**AAFC MRDC: CHILLER
& BOILER UPGRADE
(CHILLER SCOPE ONLY)**

**ADDENDUM 1
DEMOLITION PLAN**

Project no.
R.111908

**ADDENDUM 1
MECHANICAL PLAN**

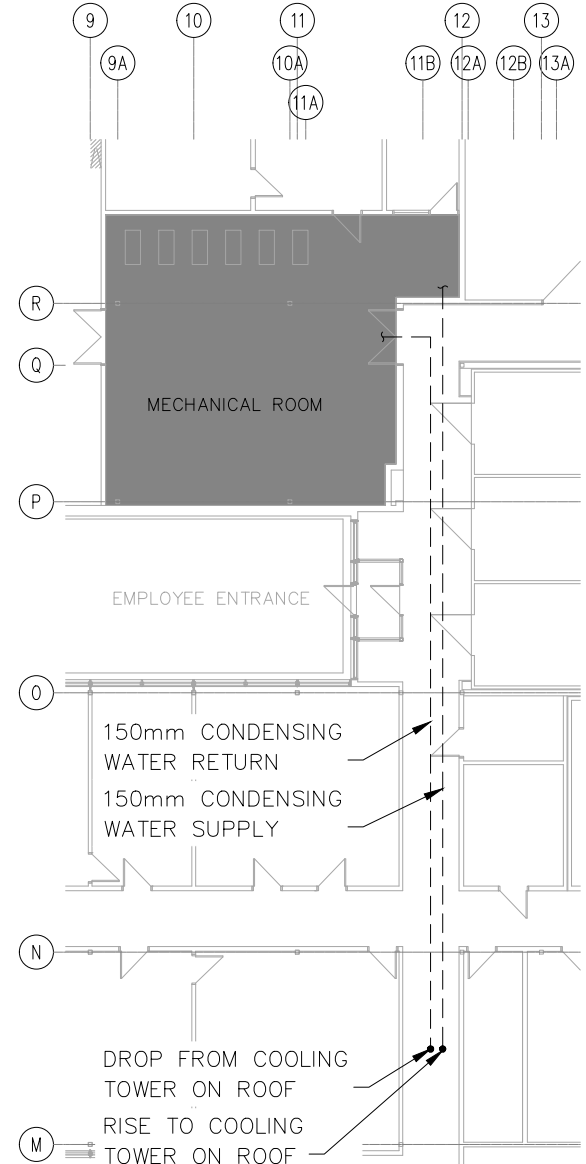
1. REMOVE ALL CONDENSER WATER PIPING FROM MECHANICAL ROOM TO COOLING TOWER AND ALL ASSOCIATED HANGERS. PIPING IS LOCATED IN CEILING OF MAIN FLOOR WHICH IS ACCESSIBLE THROUGH THE CORRIDORS.

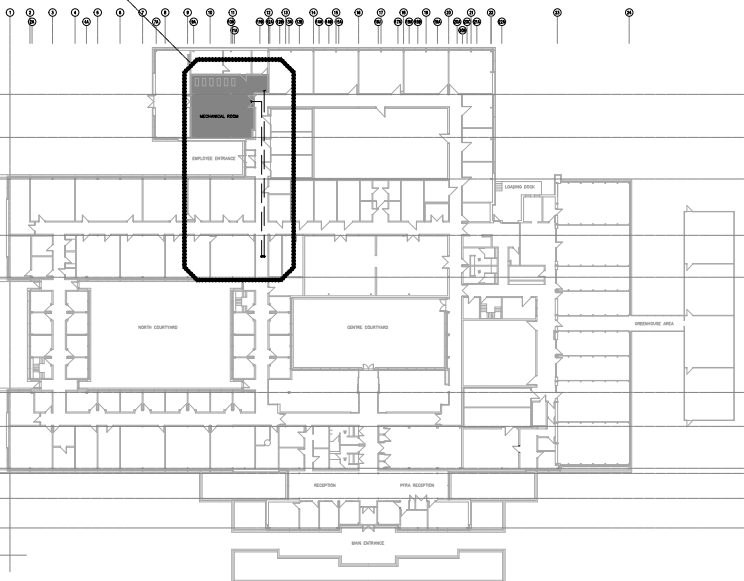
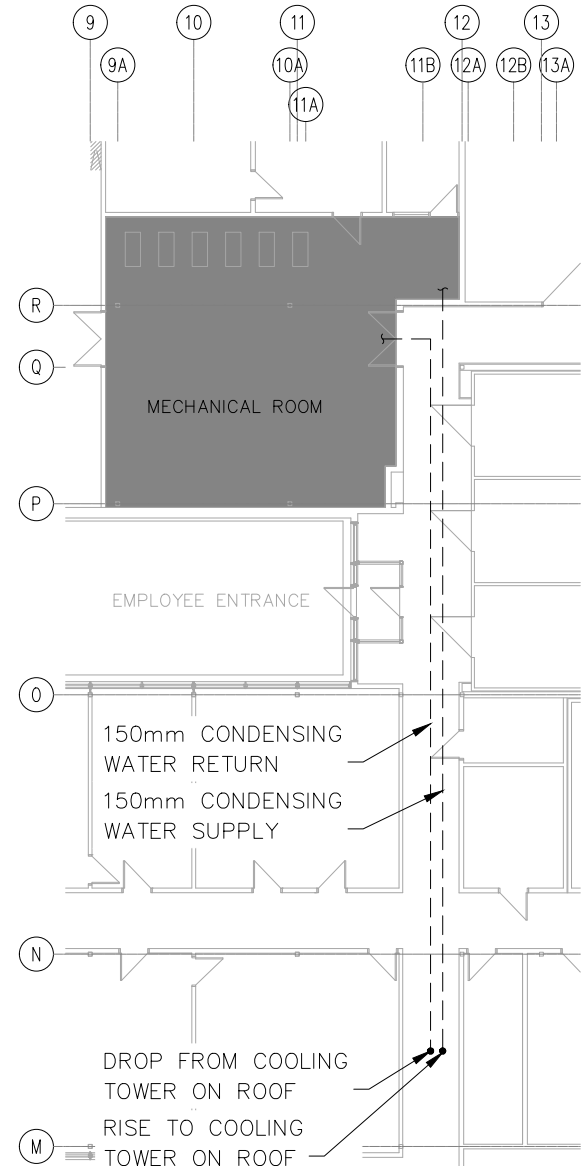
1. INSTALL NEW CONDENSER PIPING IN THE SAME LOCATION FROM MECHANICAL ROOM TO COOLING TOWER. INSTALL ALL NEW MOUNTING HARDWARE IN SAME POSITION.
